THE CITY OF KEY WEST

ADDENDUM NO. 2 – AQUARIUM SEAWALL REPAIR ITB 18-036

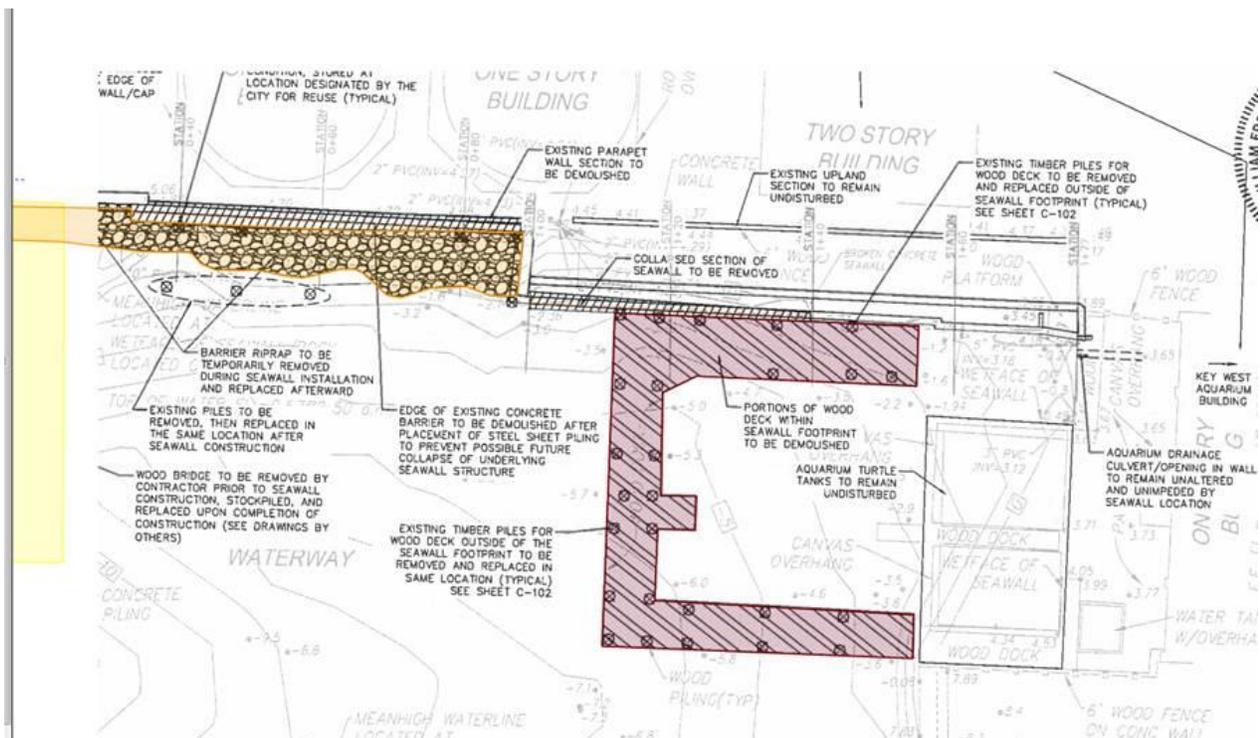
2. In page C-101 the existing wood deck (shown in red below) call to be removed and stockpiled during construction and replaced. The construction plans do not show any details in how and what kind of materials should be replaced.

Remove only wood decking and pilings required for wall installation. Bidder will not be required to replace any decking. All pilings removed will be required to be replaced per the plans.
